# Arboricultural Impact Assessment

**SITE ADDRESS**  
**37 BAKERS ROAD**  
**CHURCH POINT NSW 2105**

**Prepared by Chantalle Brackenridge Hughes**  
Consulting Arboriculturist & Horticulturist  
Diploma of Arboriculture AQF Level 5

**OCTOBER 2023**

Figure 1 – Tree 1 encroachment – Mark up of Granny Flat Plan, dwg no. A.03, 12/5/23 authored by Gartner Trovato Architects. Red dotted circle notes SRZ, blue shaded circle TPZ, pink shading is encroachment. Marked up by Treeism. NOT TO SCALE.

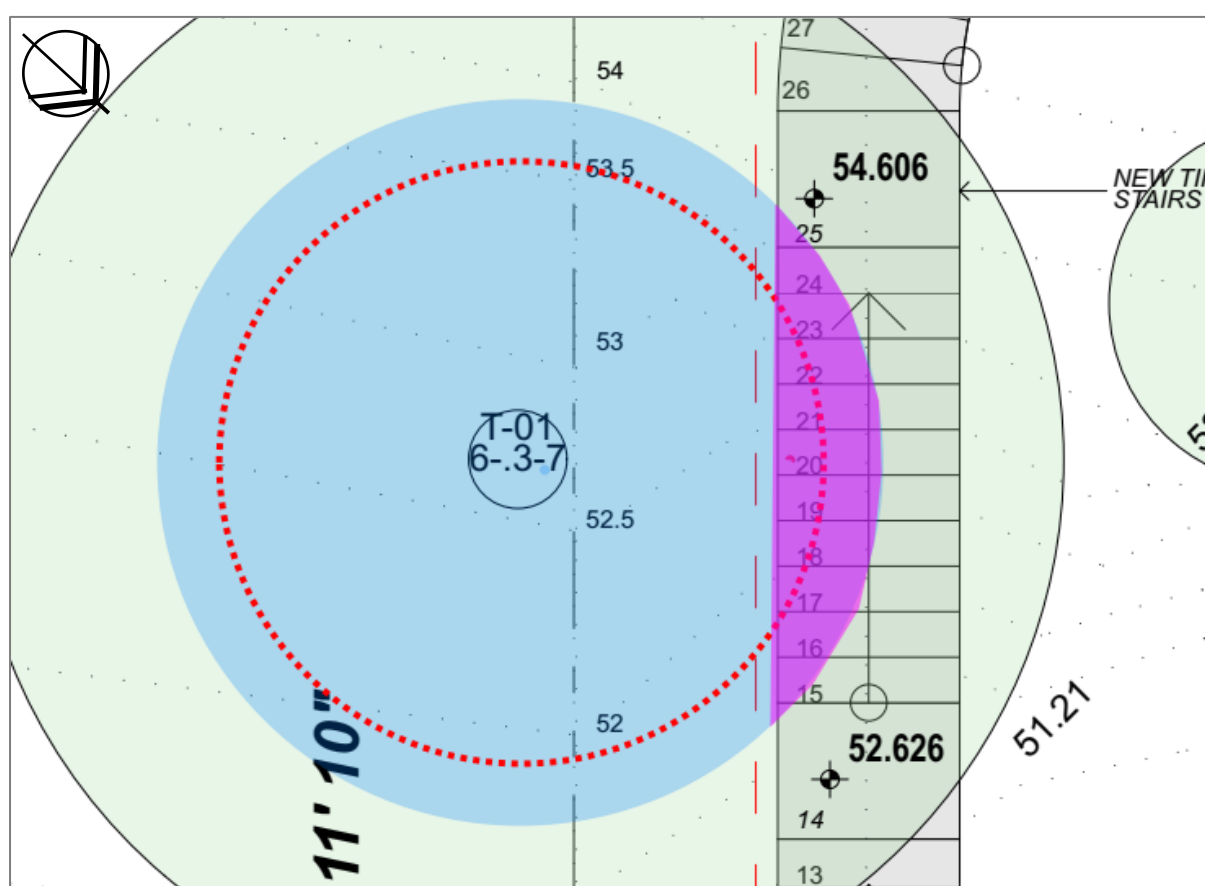
- The proposed timber stairs fall within the calculated SRZ of this specimen. Further discussion below.

- The proposed timber access stairs fall inside the TPZ of this specimen (see Figure 1 below), an 8.7% encroachment has been estimated. Given the timber stair encroachment also falls within the SRZ, this level of encroachment is considered *major* under AS4970 and triggers Clause 3.3.4 - TPZ encroachment considerations under AS4970 - 2009.
- The primary consideration is (b) *The potential loss of root mass resulting from the encroachment: number and size of roots and* (h) *Design Factors*.
- Given the stairs will be on piers only the level of encroachment is greatly reduced. Negative impact to tree health/condition is considered unlikely.

Figure 2 – Tree 2 & 3 encroachment – Mark up of Granny Flat Plan, dwg no. A.03, 12/5/23 authored by Gartner Trovato Architects. Red dotted circle notes SRZ, blue shaded circle TPZ, pink shading is encroachment. Note nil encroachment Tree 5 & 6. Marked up by Treeism. NOT TO SCALE.

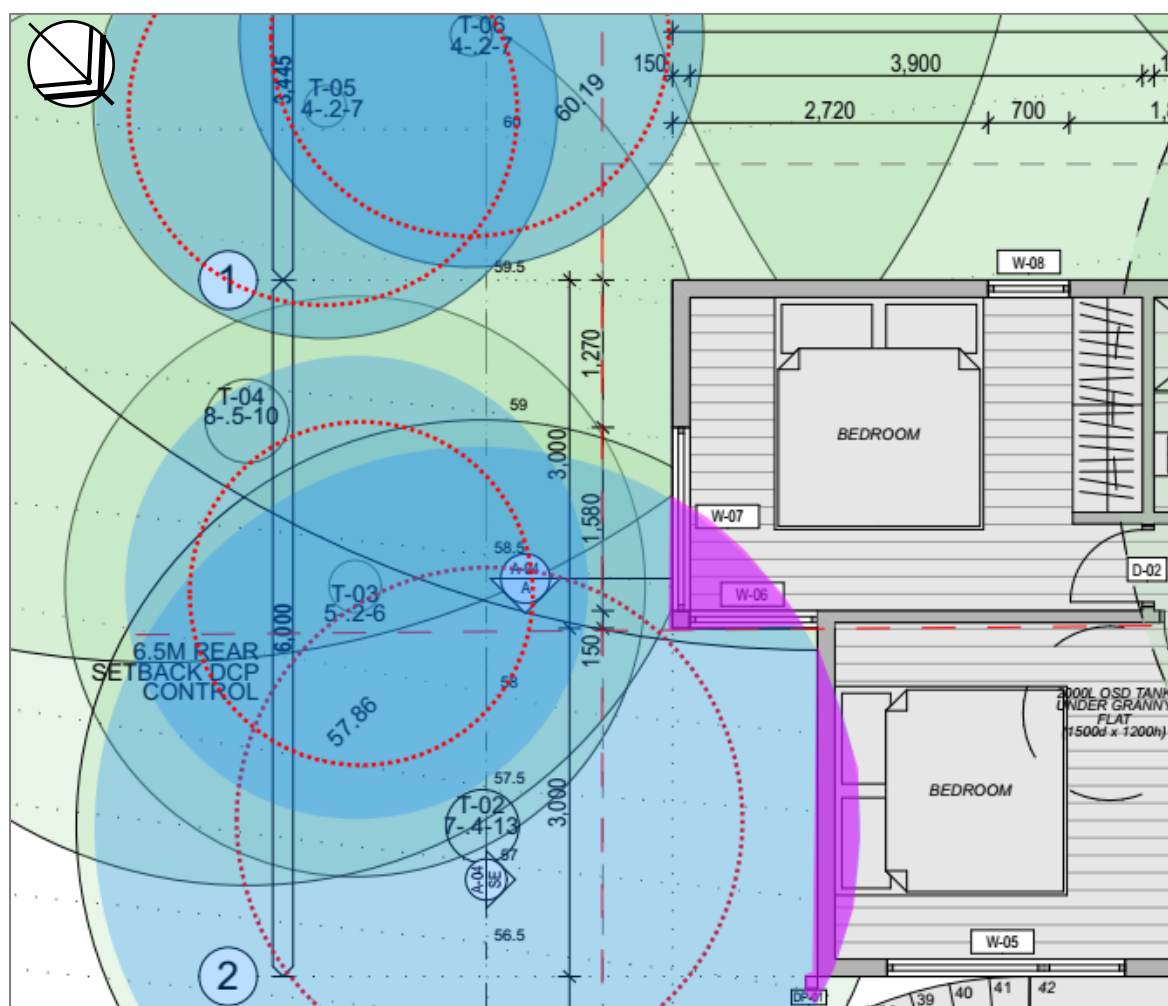
- The proposed Granny Flat falls inside the TPZ of this specimen (see Figure 2 below), an 4.5% encroachment has been estimated. This level of encroachment is considered *minor* under AS4970 and impacts to tree health and condition not foreseen.
- Additionally, this section of the Granny Flat will be located on isolated piers, further reducing any impacts on this specimen.

- No works are proposed within the TPZ of this specimen (see Figure 2 below).

- No works are proposed within the TPZ of this specimen (see Figure 2 page 8 above).

- No works are proposed within the TPZ of this specimen (see Figure 2 page 8 above).

Figure 3 – Tree 4 encroachment – Mark up of Site Plan & Site Analysis, dwg no. A.01, 12/5/23 authored by Gartner Trovato Architects. Red dotted circle notes SRZ, blue shaded circle TPZ, pink shading is encroachment. Marked up by Treeism. NOT TO SCALE.

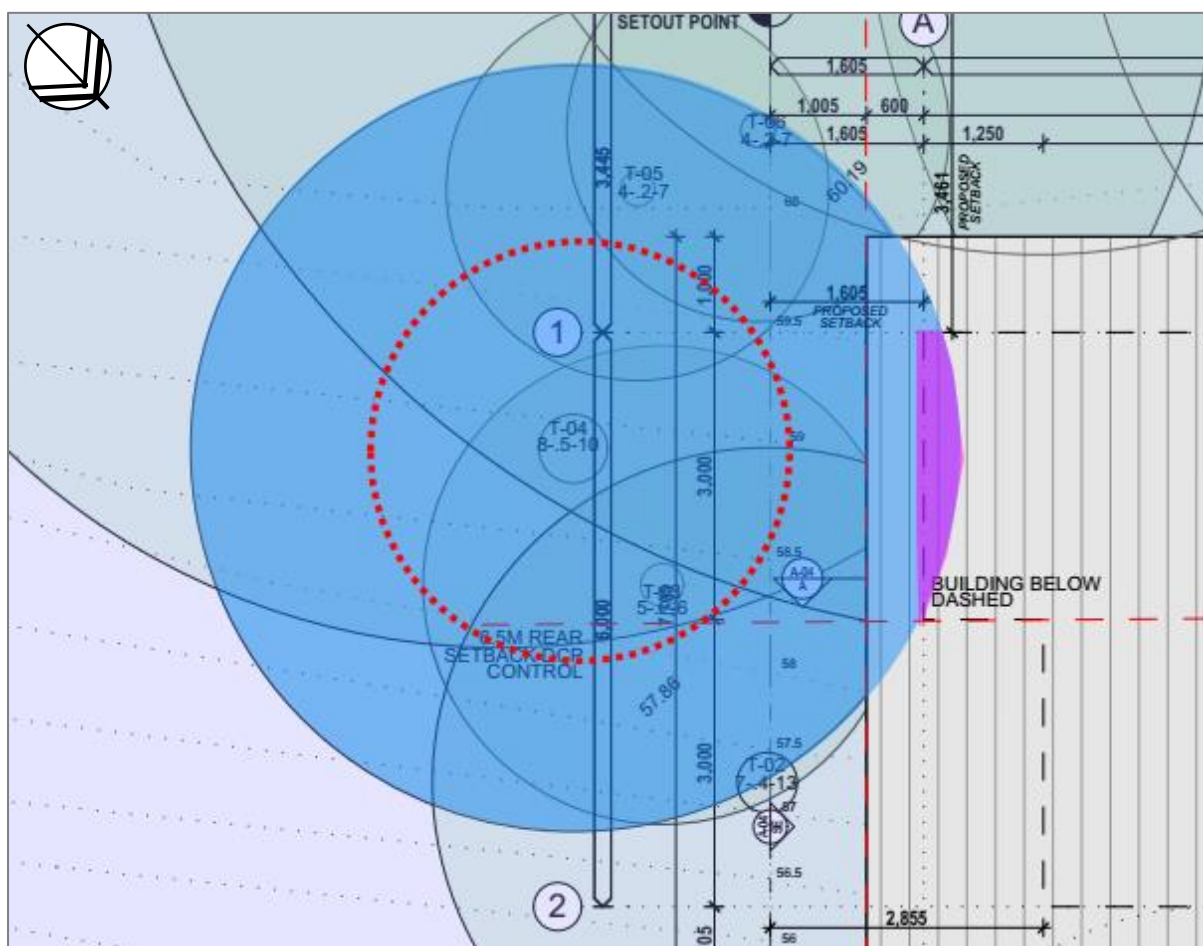
- The proposed Granny Flat falls inside the TPZ of this specimen (see Figure 3 below), an 2.1% encroachment has been estimated. This level of encroachment is considered *minor* under AS4970.
- Additionally, the northern portion of this encroachment will be located on isolated piers, further reducing any potential impacts to tree health and condition.

- Potential minor pruning may be required to allow clearances for the proposed Granny Flat.

Figure 4 – Tree 10 – Mark up of Site Plan & Site Analysis, dwg no. A.01, 12/5/23 authored by Gartner Trovato Architects. Red dotted circle notes SRZ, blue shaded circle TPZ, pink shading is encroachment – piers only, orange shading permanent encroachment. Marked up by Treeism. NOT TO SCALE.

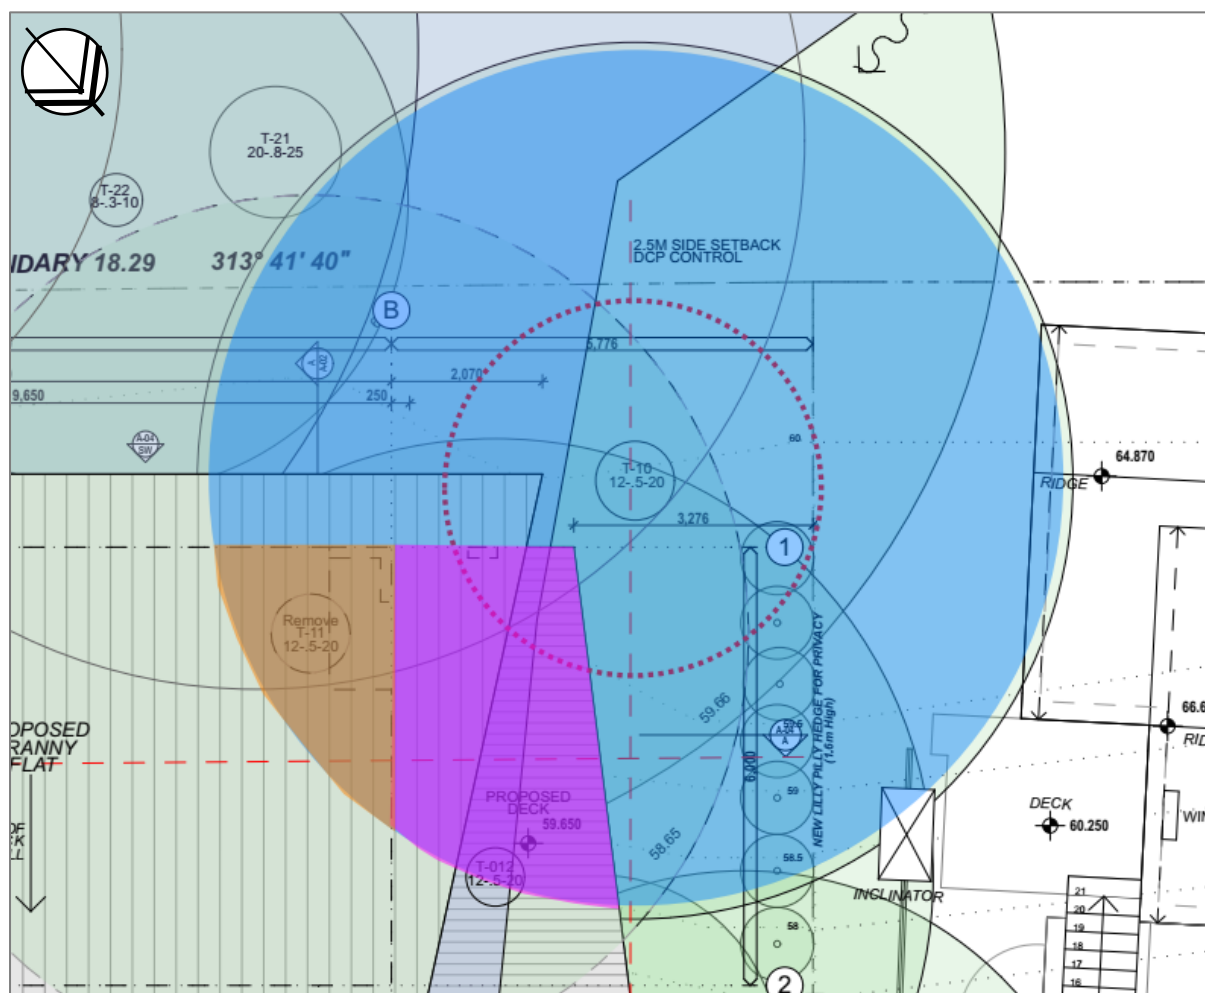
- The proposed deck for the Granny Flat falls within the SRZ of this specimen. It will be on isolated piers thus reducing impacts.

- A theoretical encroachment of 17.7% has been estimated (see Figure 4 below). This is considered a *major* encroachment under AS4970 and triggers Clause 3.3.4 - TPZ encroachment considerations under AS4970 - 2009. The primary consideration is (b) *The potential loss of root mass resulting from the encroachment: number and size of roots and* (h) *Design Factors*.
- The pink shading in Figure 4 denotes the section on isolated piers, the orange section is an excavation into the bank on the south-west side only. This 'permanent' encroachment has been calculated at 6% encroachment. Pier placement could be a little flexible to avoid woody root disturbance, long term negative impact on tree health is unlikely.

Figure 5 – Tree 12 encroachment – Mark up of Granny Flat Plan, dwg no. A.03, 12/5/23 authored by Gartner Trovato Architects. Red dotted circle notes SRZ, blue shaded circle TPZ, pink shading is encroachment – piers only, orange shading permanent encroachment. Marked up by Treeism. NOT TO SCALE.

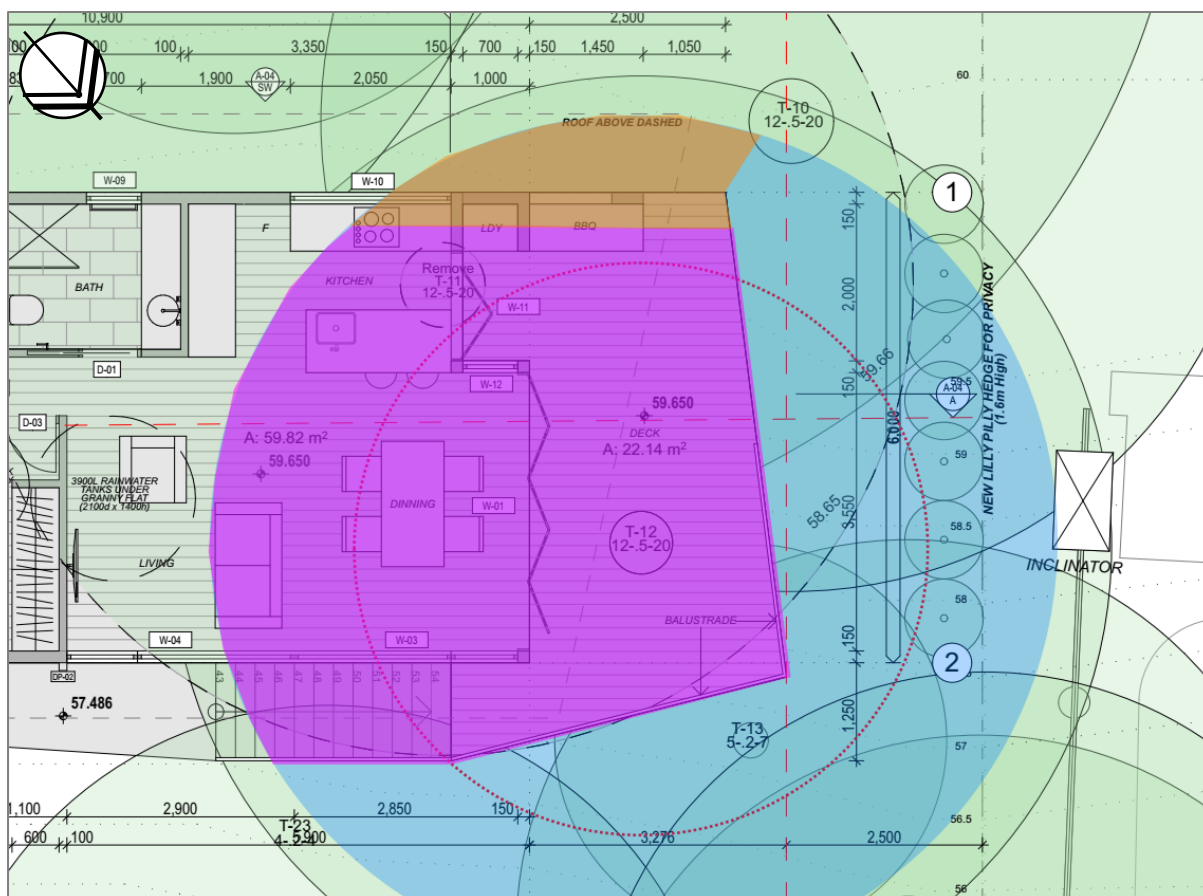
- The proposed deck for the Granny Flat falls within the SRZ of this specimen. It will be on isolated piers thus reducing impacts.

- A theoretical encroachment of 52.7% has been estimated (see Figure 5 below). This is well within *major* encroachment under AS4970 and triggers Clause 3.3.4 - TPZ encroachment considerations under AS4970 - 2009. Again, the primary considerations are (b) *The potential loss of root mass resulting from the encroachment: number and size of roots and* (h) *Design Factors*.

- The pink shading in Figure 4 denotes the section on isolated piers, the orange section is an excavation into the bank on the south side. This 'permanent' encroachment has been calculated at 5.8% encroachment. Pier placement would need to be flexible to avoid woody root disturbance. Adequate space around the tree stem will be required to accommodate stem/trunk expansion.

- Minor to moderate impacts in the short to medium term are likely but will depend on the potential disturbance of woody roots and any offset watering in the short term to ameliorate the rain-shadow.

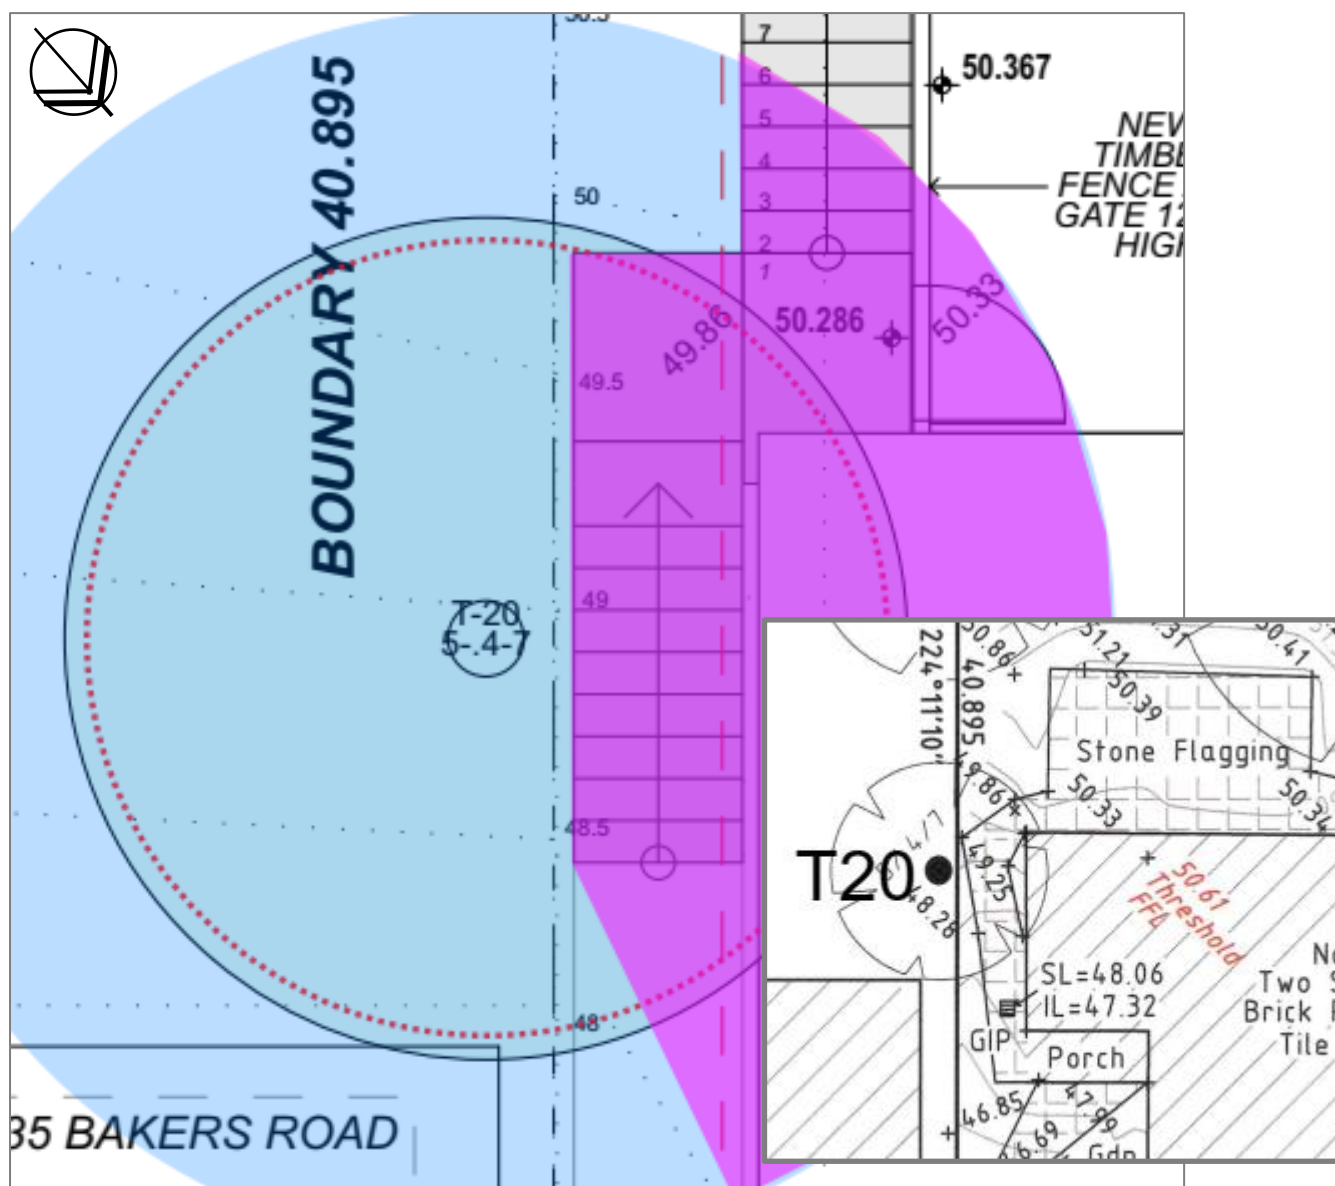
- The proposed access stairs for the Granny Flat falls within the SRZ of this specimen. They are proposed as light-weight timber stairs on isolated piers, thus reducing impacts.
- Existing stone flagging is also located within this area (see Inset of Figure 6 below/next page).

- A theoretical encroachment of 35.6% has been estimated (see Figure 6 page 15). This is considered *major* encroachment under AS4970 and triggers Clause 3.3.4 - TPZ encroachment considerations under AS4970 - 2009. Again, the primary considerations are (b) *The potential loss of root mass resulting from the encroachment: number and size of roots* and (h) *Design Factors*.
- The pink shading in Figure 4 denotes the deck encroachment, this is proposed to be on isolated piers. Provided pier placement is flexible to avoid woody root disturbance impact to tree health should be minimal.

Figure 7 – Tree 21 and 22 – Mark up of Site Plan & Site Analysis, dwg no. A.01, 12/5/23 authored by Gartner Trovato Architects. Red dotted circle notes SRZ, blue shaded circle TPZ, pink shading is encroachment – piers only, orange shading permanent encroachment. Marked up by Treeism. NOT TO SCALE.

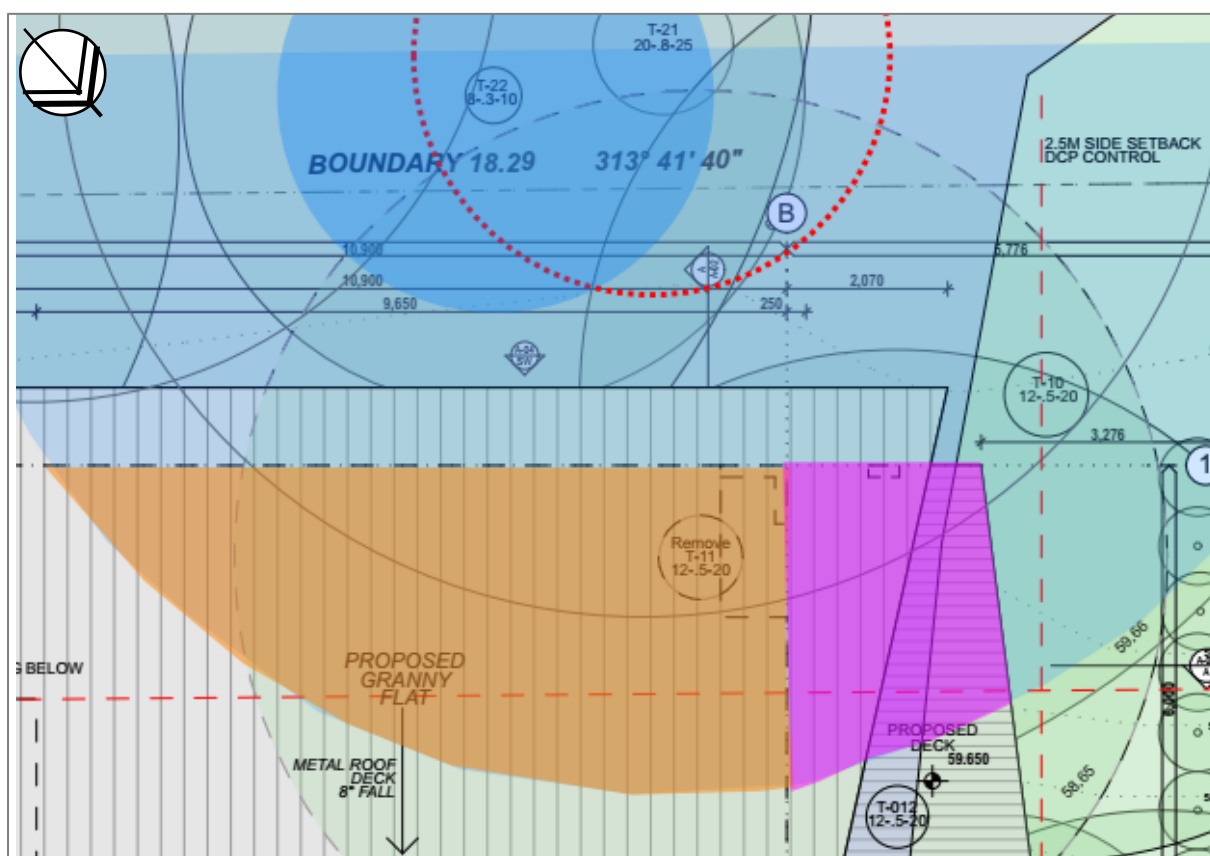
- An encroachment of 13.7% has been estimated (see Figure 7 below). This is considered *major* encroachment under AS4970 and triggers Clause 3.3.4 - TPZ encroachment considerations under AS4970 - 2009. Again, the primary considerations are (b) *The potential loss of root mass resulting from the encroachment: number and size of roots* and (h) *Design Factors*.

- The pink shading in Figure 7 denotes the deck encroachment, this is proposed to be on isolated piers. The orange shading the more 'permanent' encroachment from the Granny Flat given the rear/southern section is an excavation. This 'permanent' encroachment equates to only 10.4% encroachment, just in the *major* encroachment category under AS4970.

- Minor to moderate impacts in the short to medium term are likely but will depend on the potential disturbance of woody roots. Access to or the restriction of moisture to this tree will remain unchanged as all works are downhill.

- All works are located outside the calculated TPZ of this specimen (see Figure 7, above/page 17).
